STAFF REPORT

PLANNING BOARD MEETING

March 8, 2017

Case #03-17: SITE PLAN REVIEW
Case #04-14: SPECIAL PERMIT FOR PARKING REDUCTION
89-93 W. Rodney French Blvd
Map 15, Lot 151

Landscaping Plan – Sheet 4 of 9

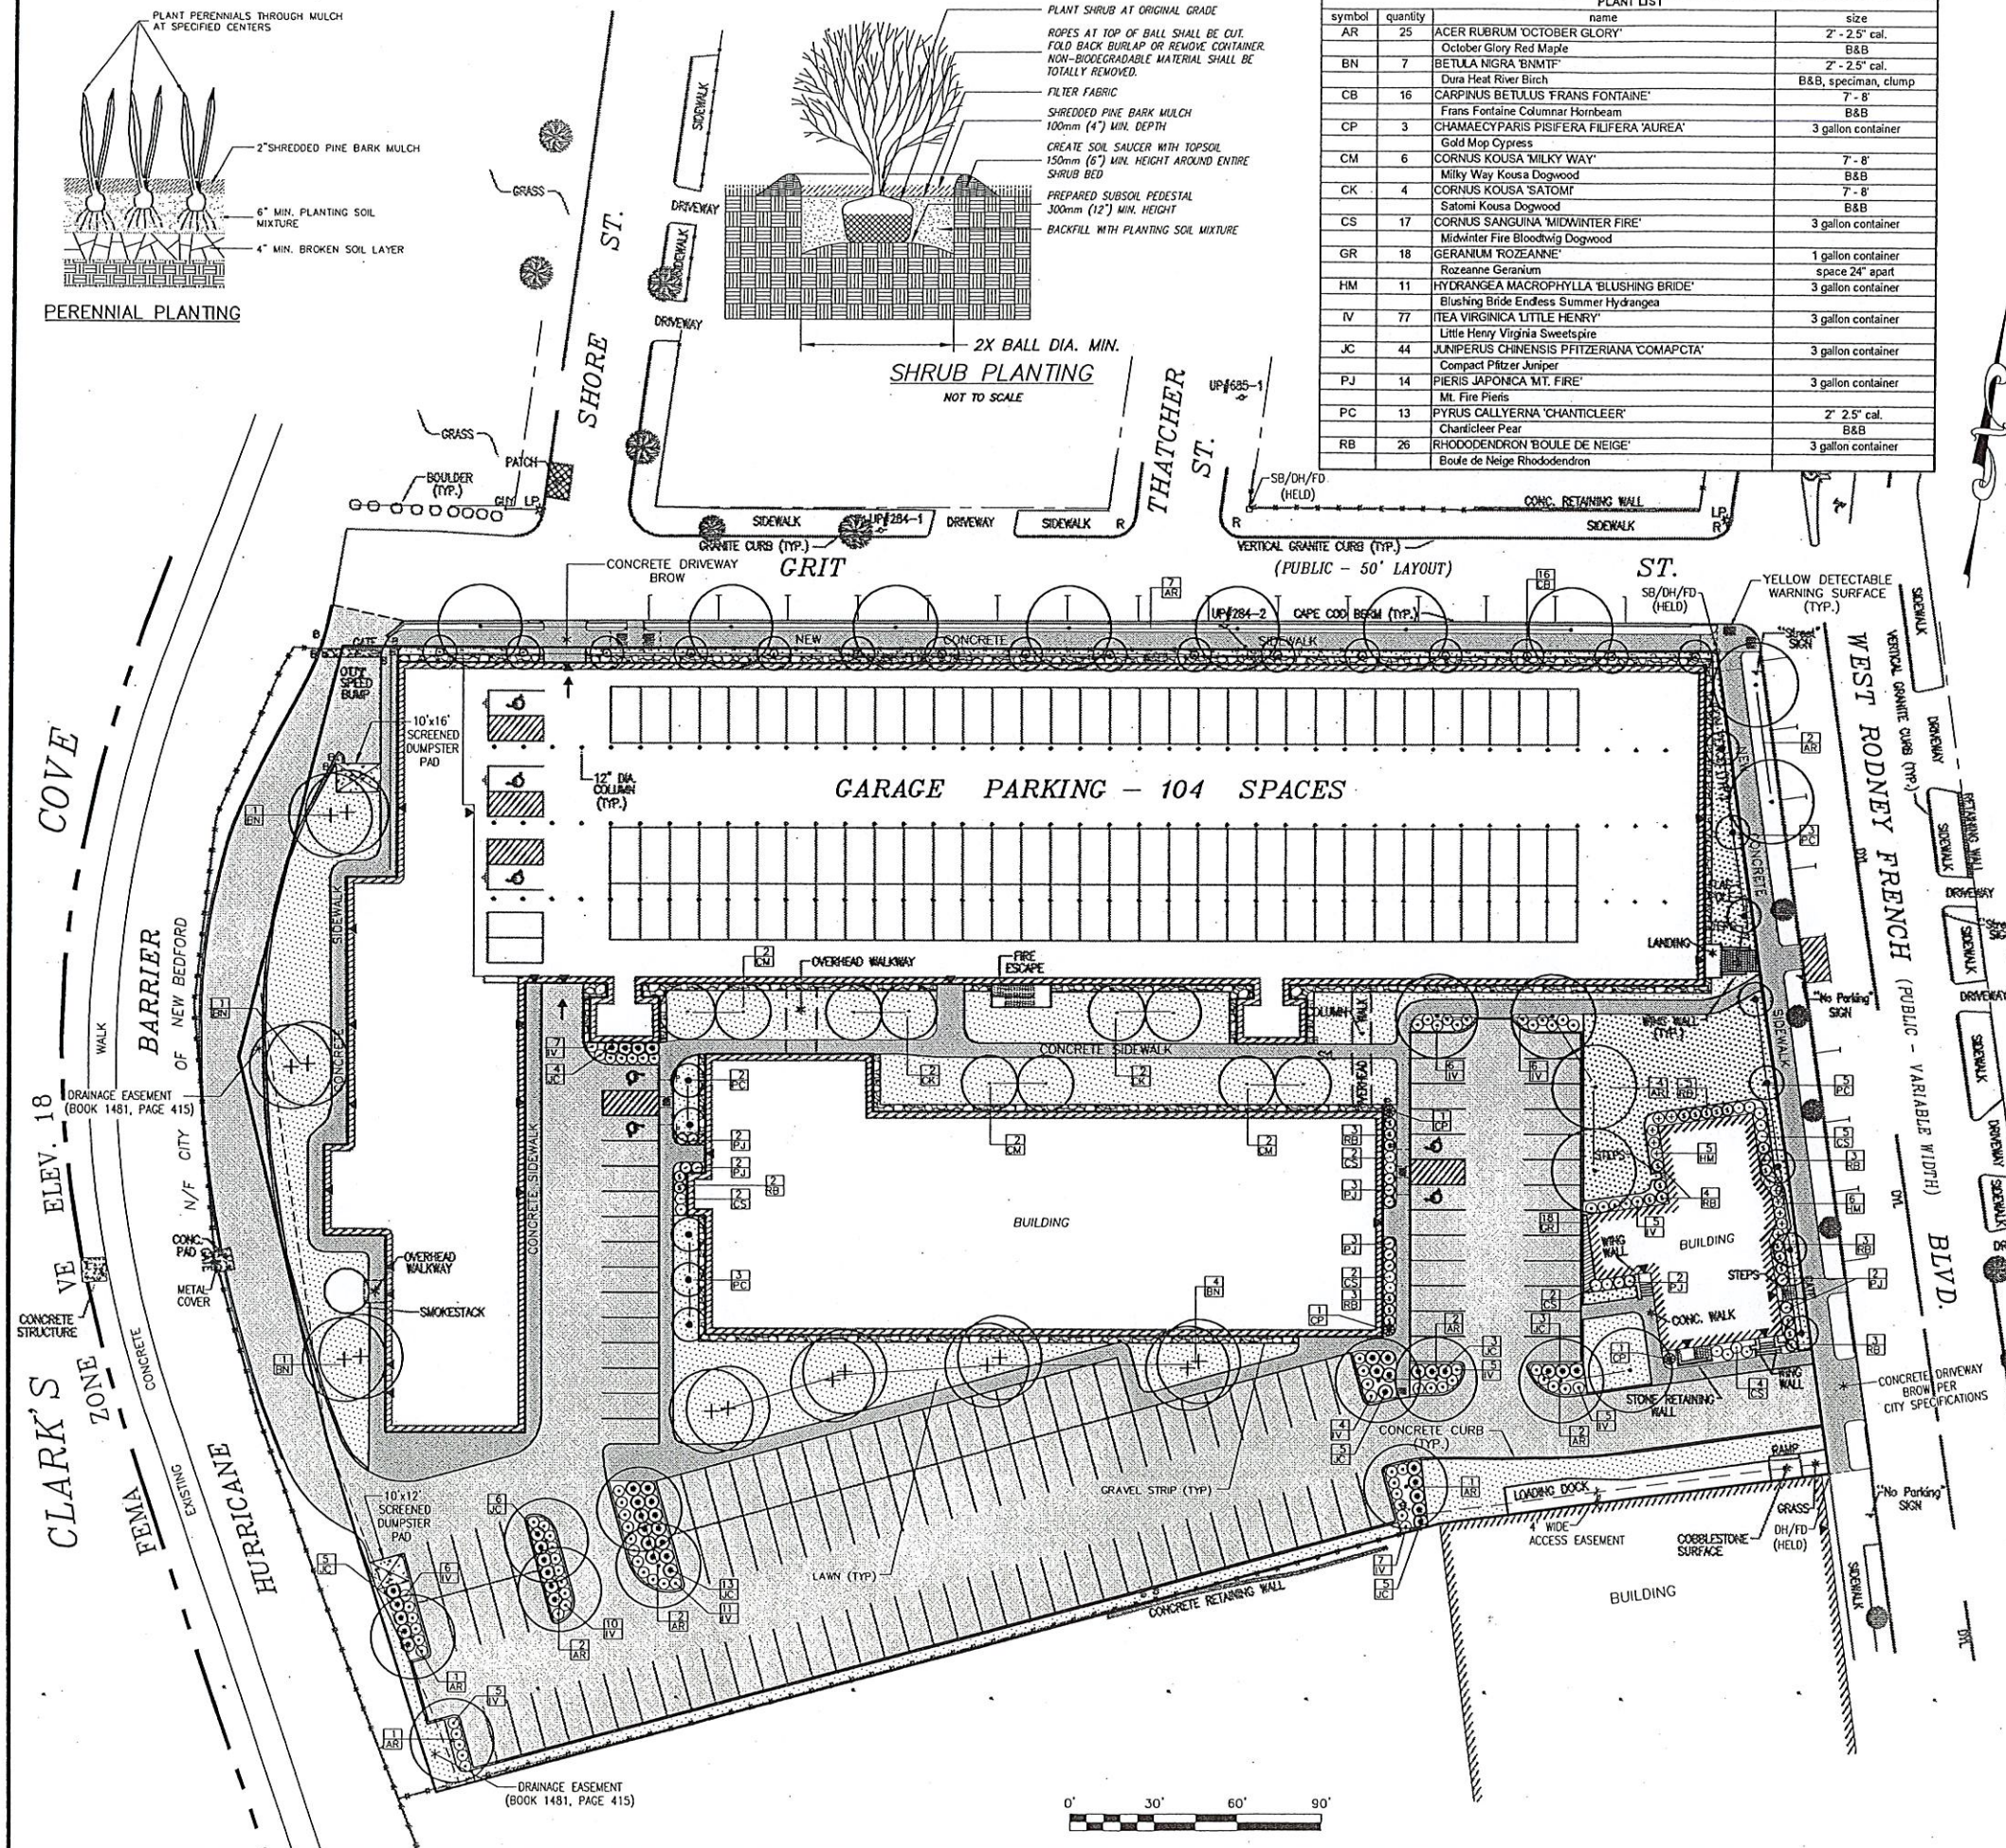
- A color landscape drawing at the Planning Board meeting would be helpful to the board.
- Missing from plan drawing as noted on Planting Schedule - one (1) October Red Glory Tree

Elevation Sheet A101

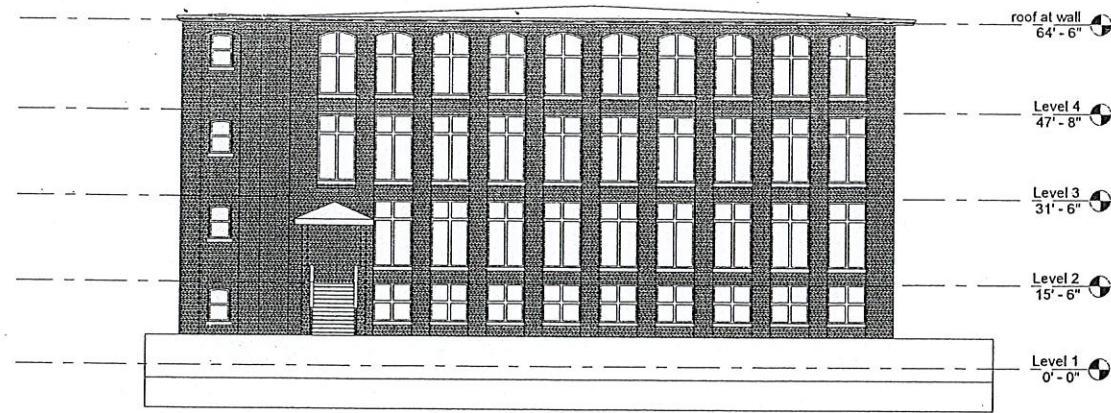
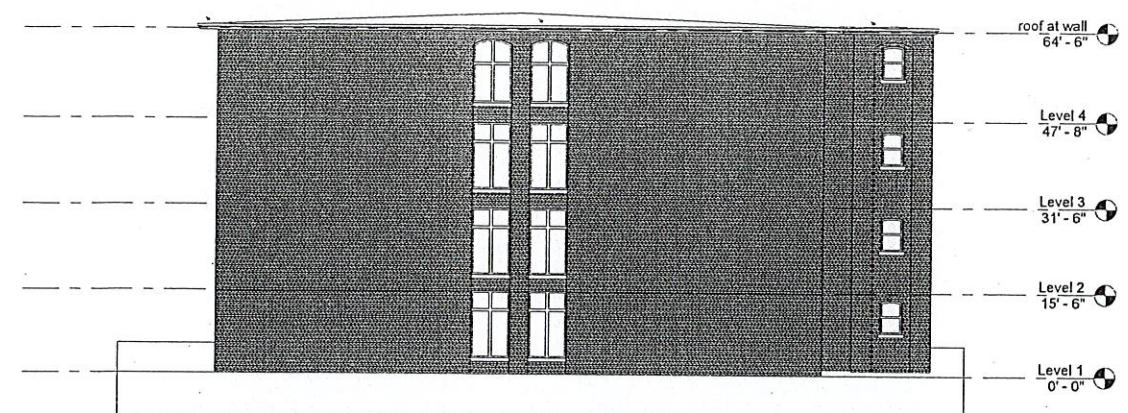
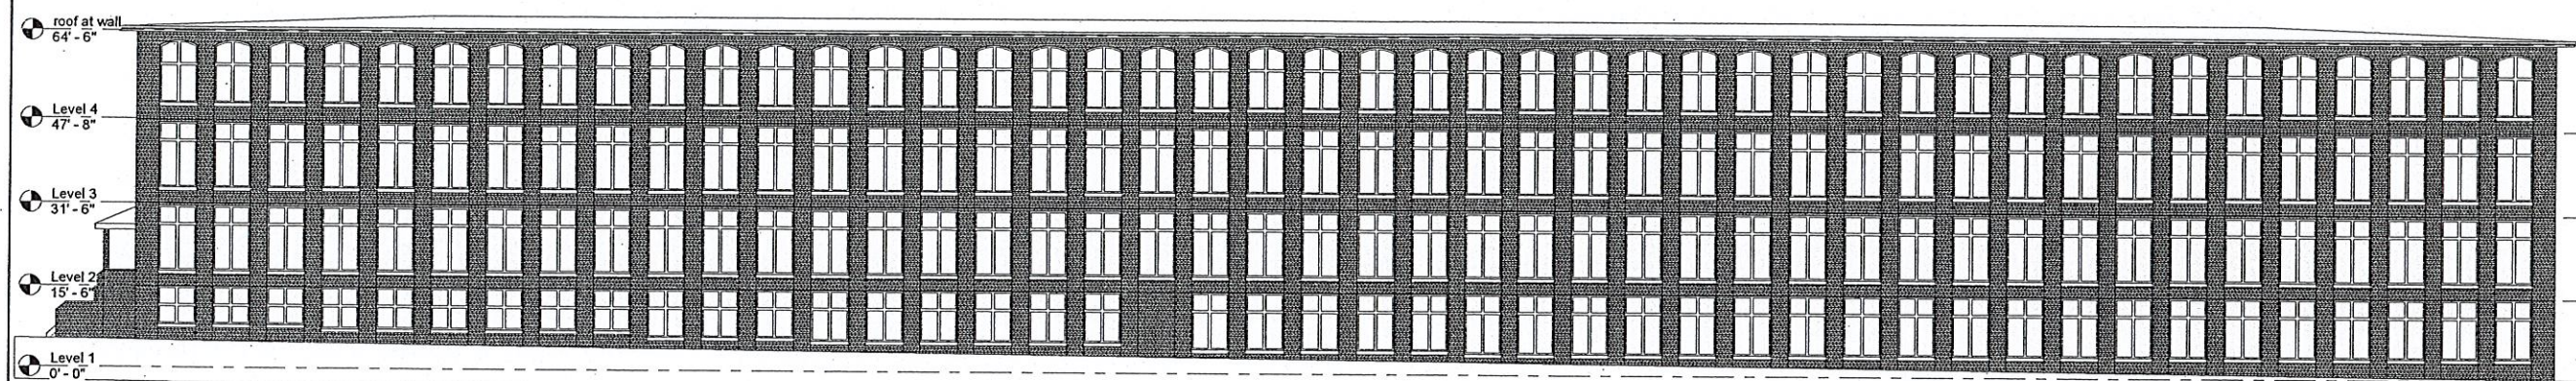
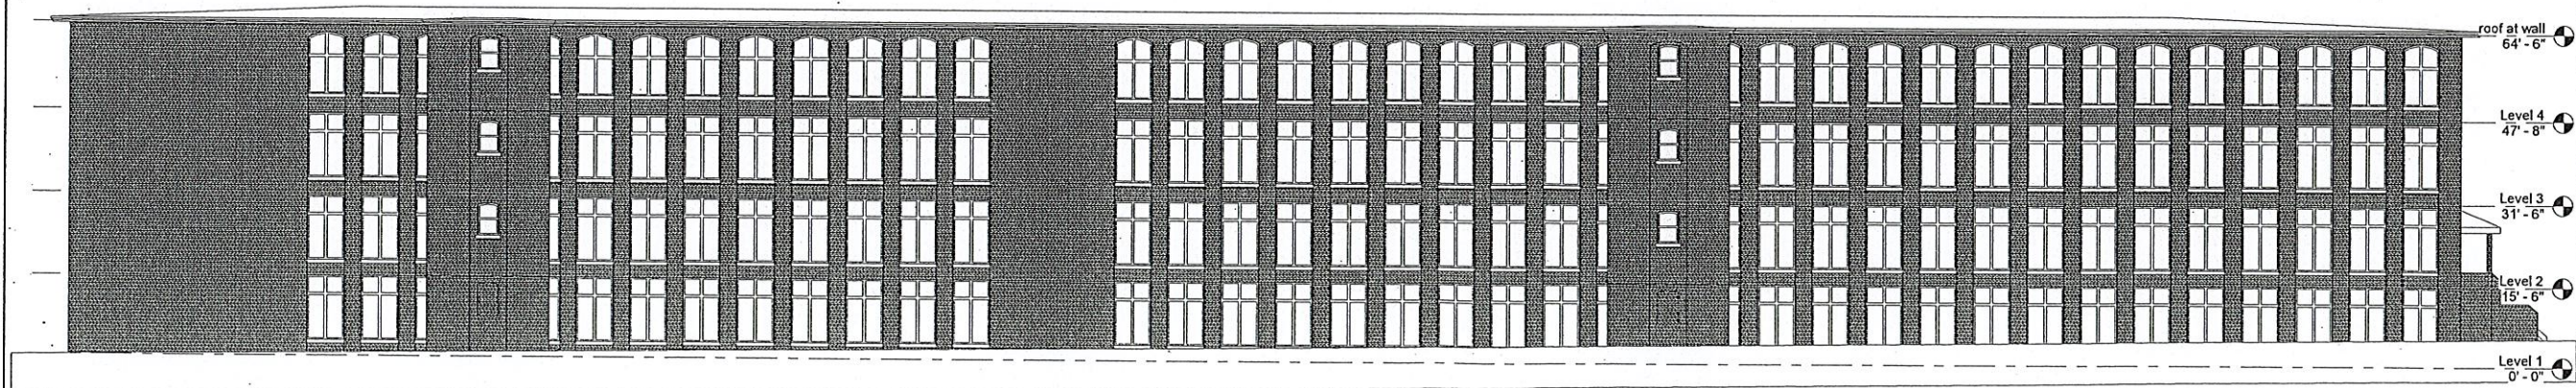
- In reviewing the elevation plan, it appears N, S, E & W elevations are for a single building at Grit Street. Palladian windows are omitted in elevation drawings for the structure aligned with Clarke's Cove. Please revise plans to include elevations for all structures under this review.
